ADDENDUM No. 1

RFP No. 23-11

Geddes Avenue and 2190 South State Street Retaining Walls

GEDDES AVENUE RETAINING WALL
RETAINING WALL PLANS
REMOVAL & CONSTRUCTION PLAN - GEDDES AVENUE
DRAWING No. 2022-009 & 2023-003-5
SHEET No.

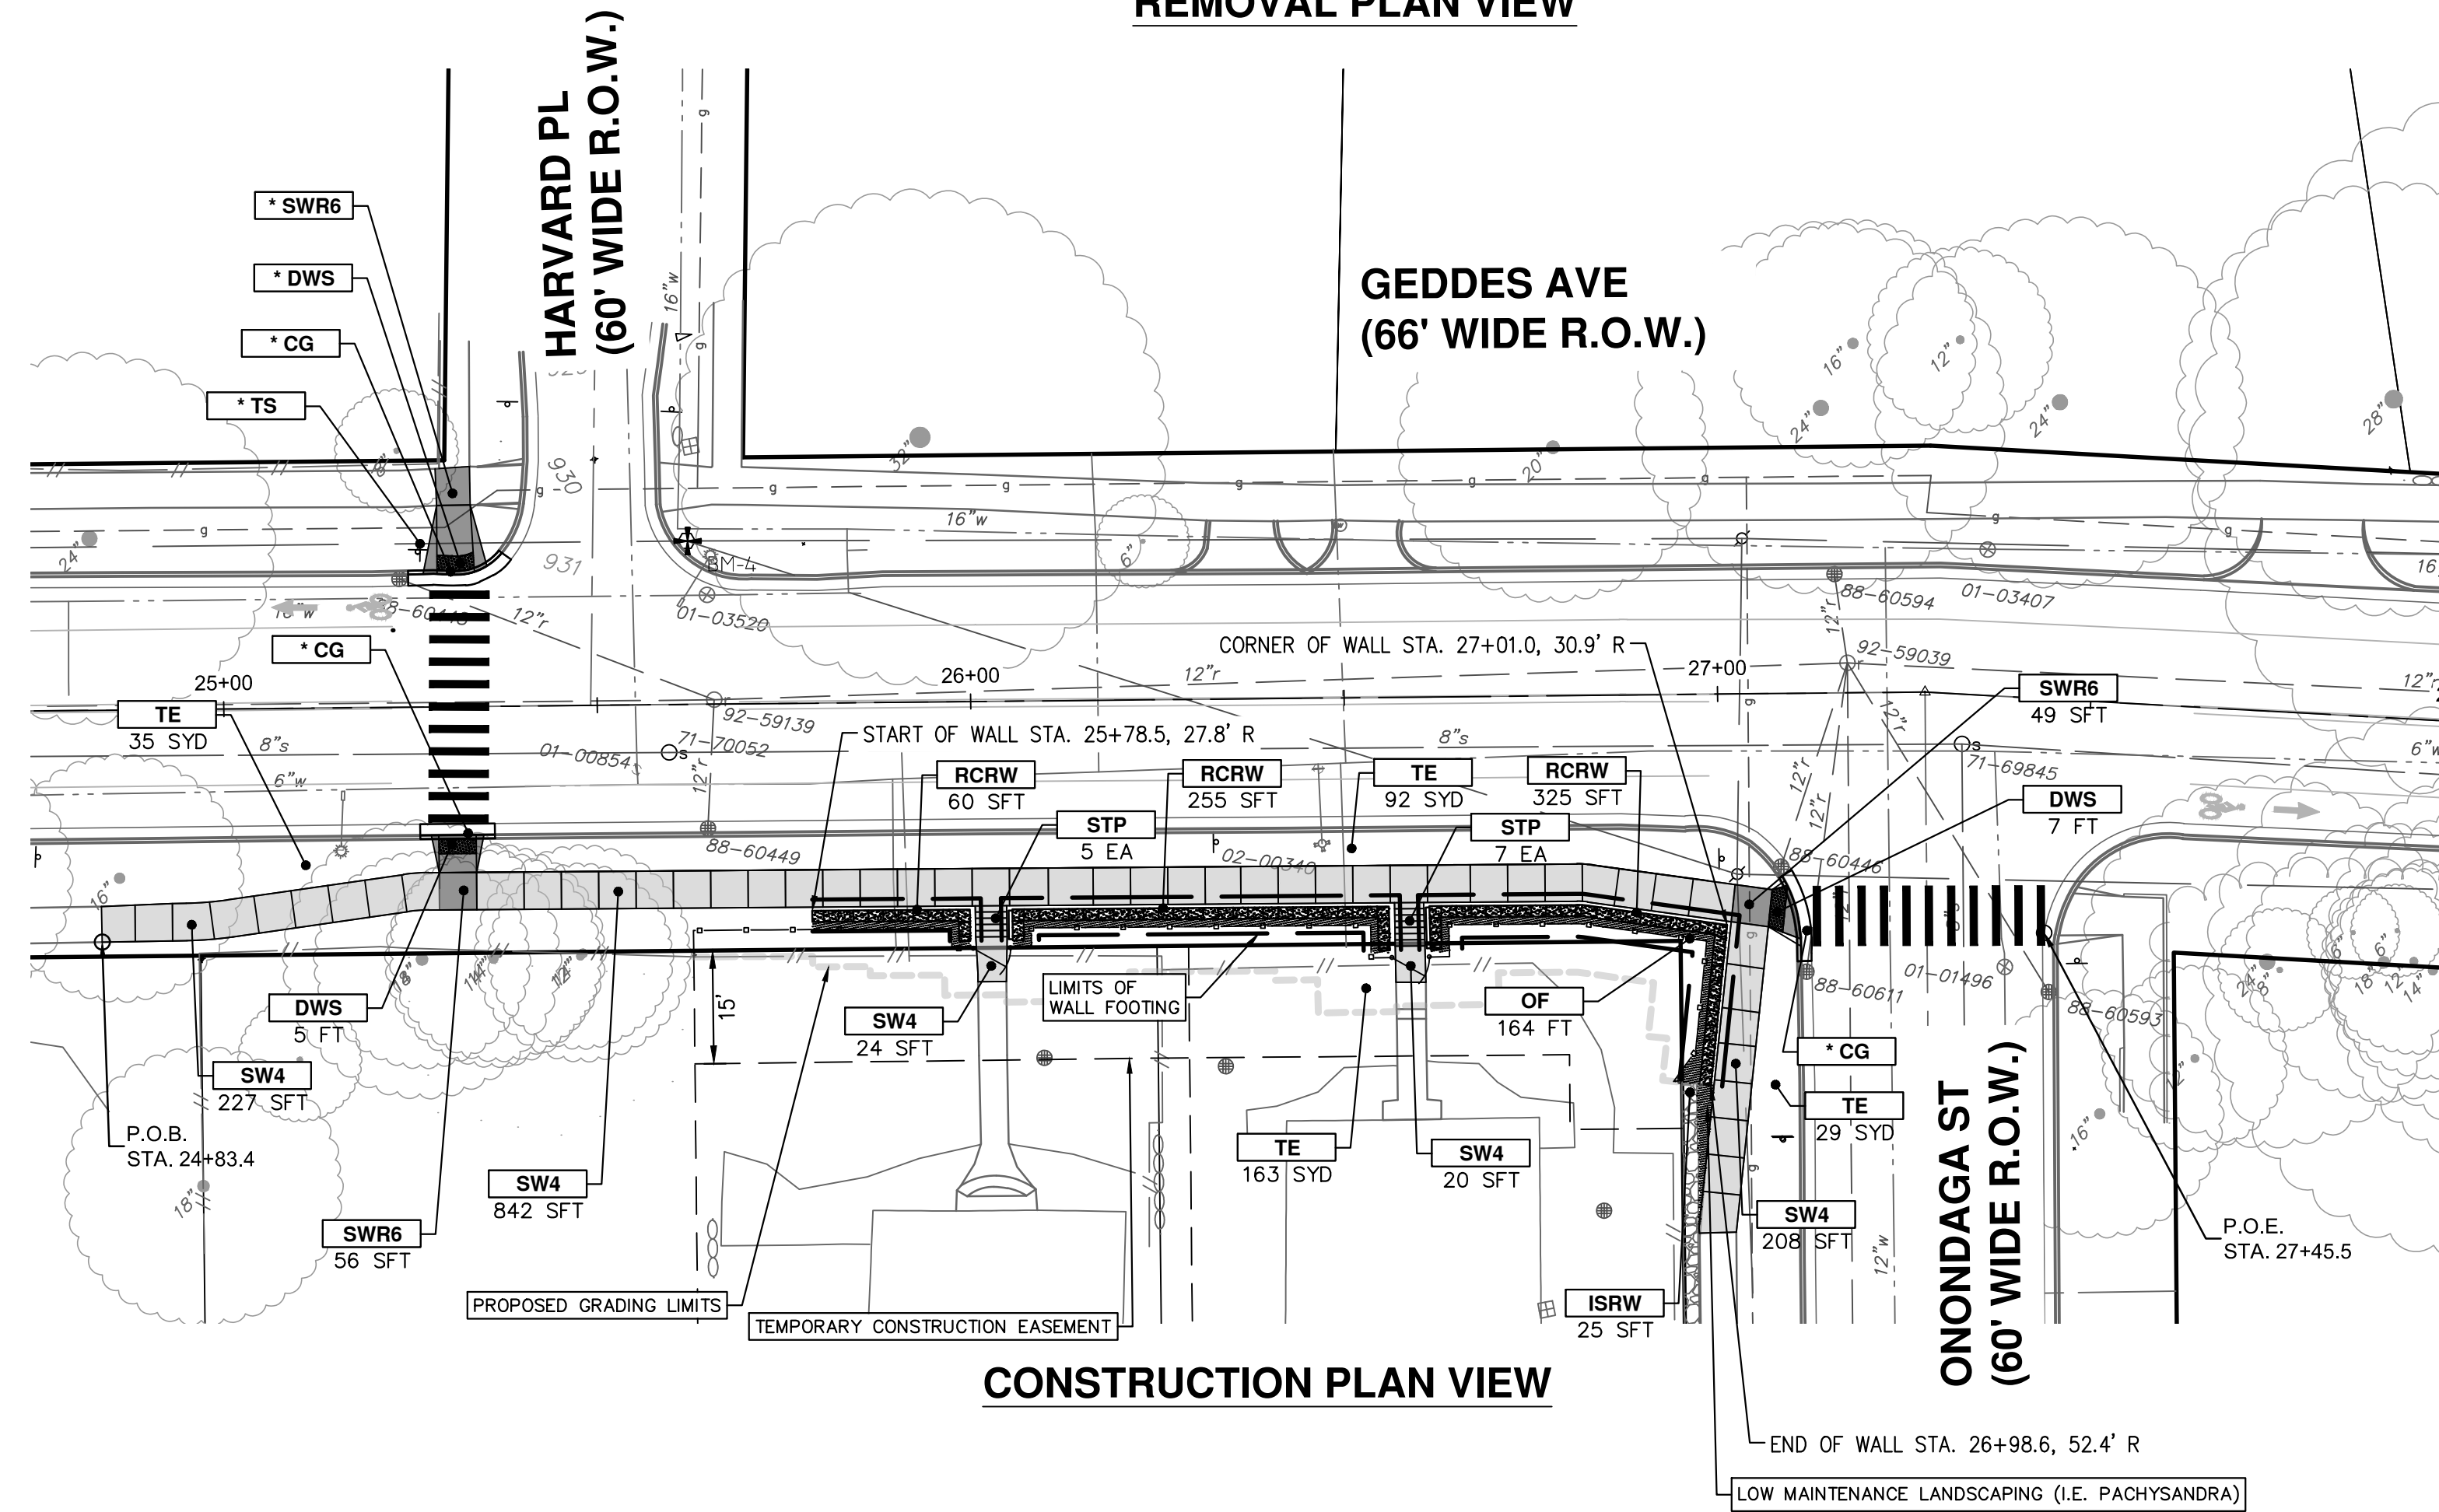
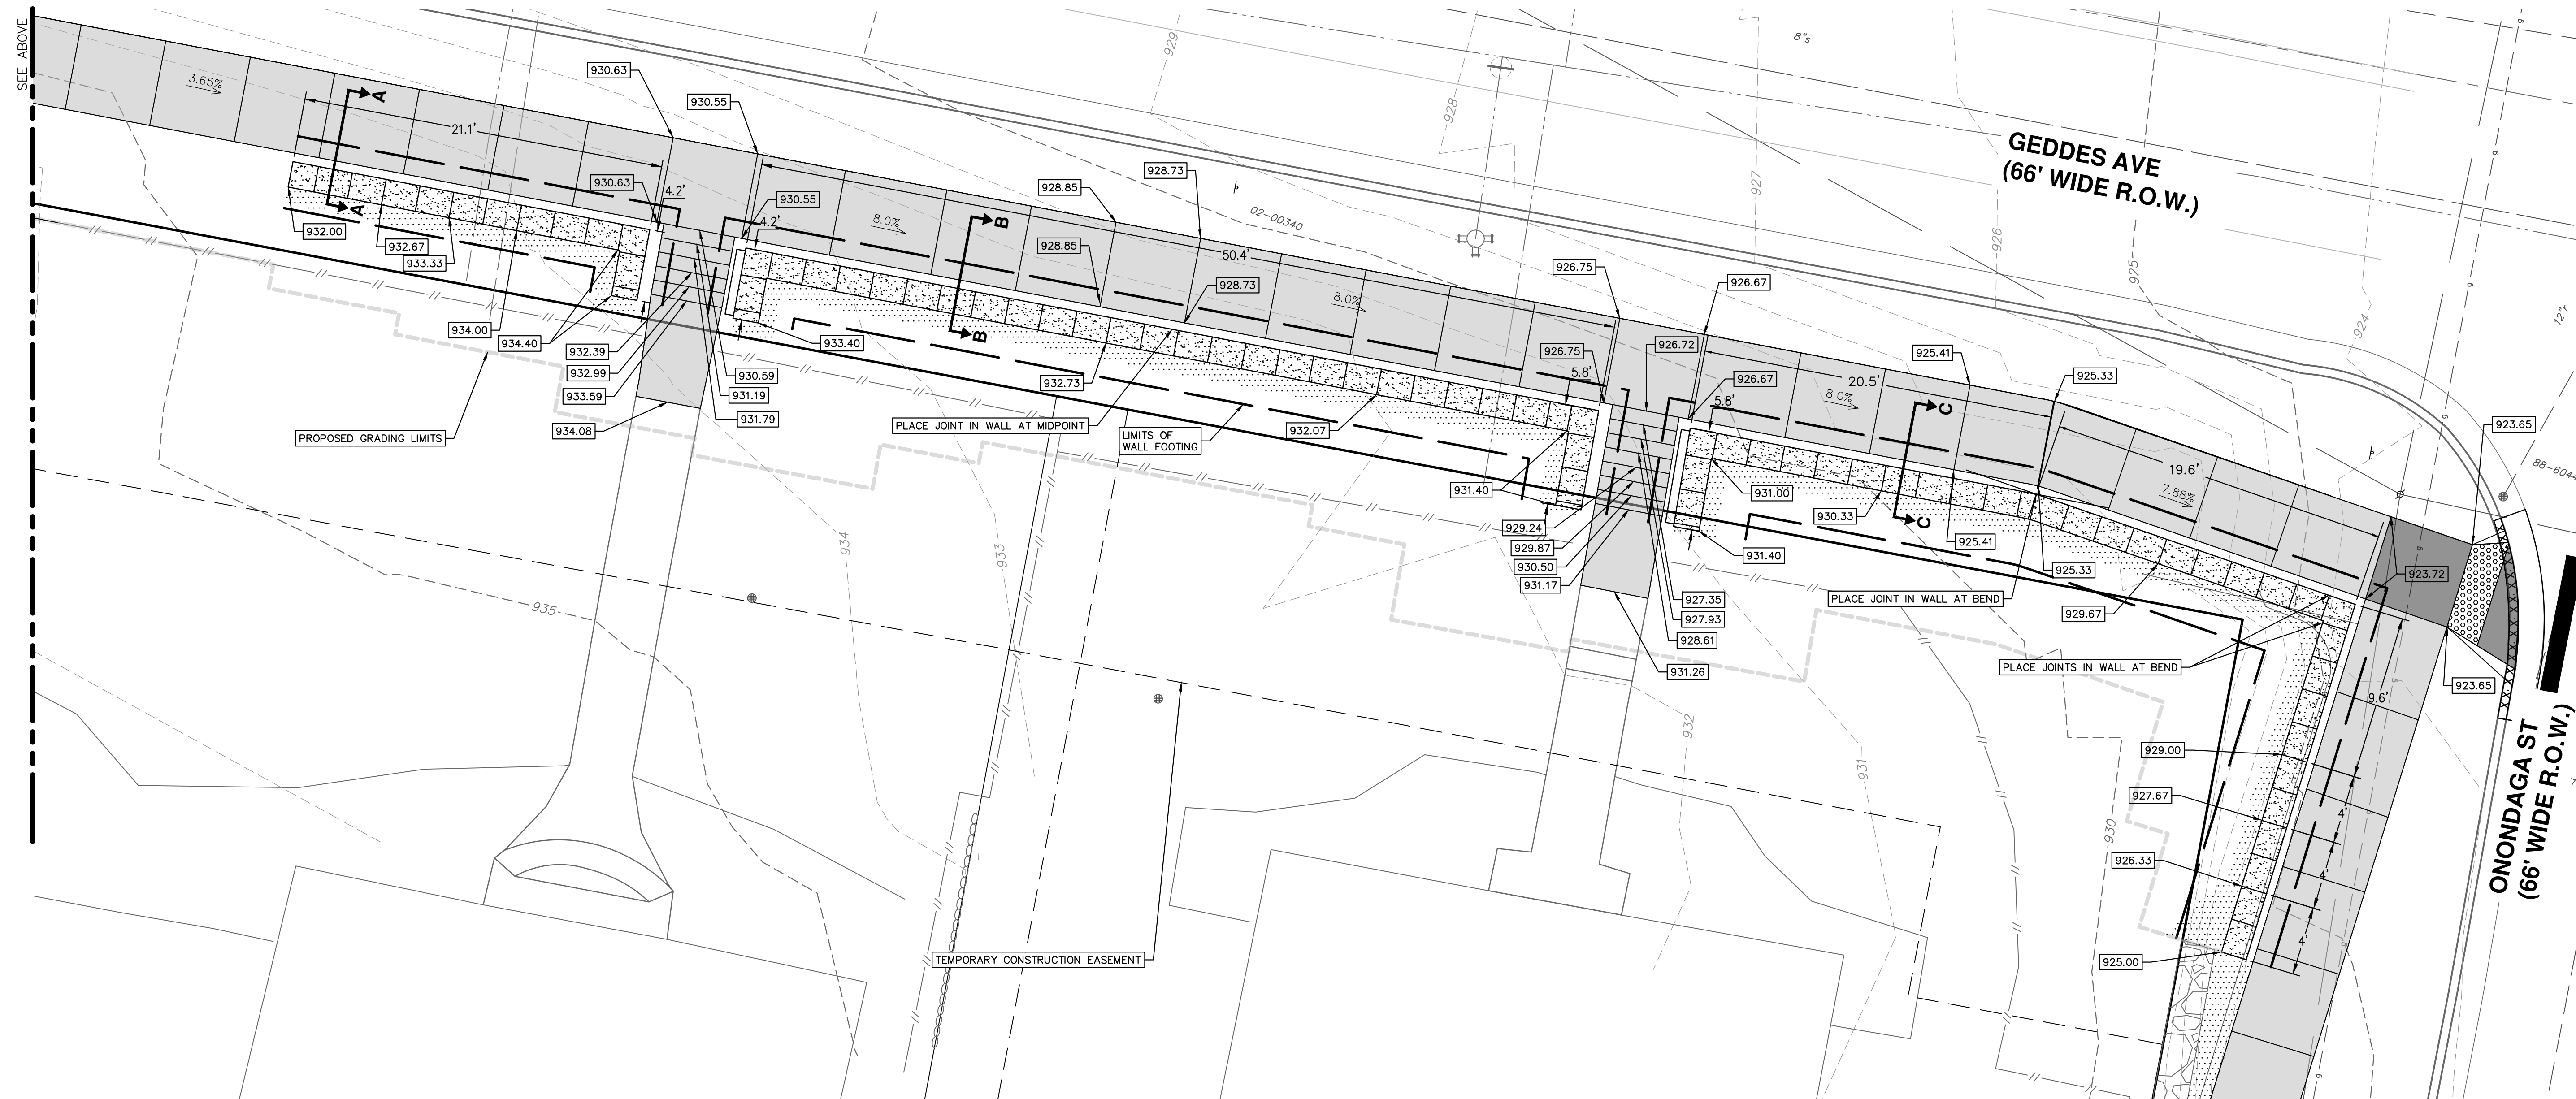
Sheet 5	Revised “Removal Key” and “Construction Key” items and descriptions to be consistent with contract pay items being used as part of the project. Adjusted the grading and temporary construction easement limits on the “Removal Plan View” and the “construction Plan View”. Added and revised call outs including quantities related to removal and construction work to reflect revisions to the “Removal Key” and “Construction Key”.
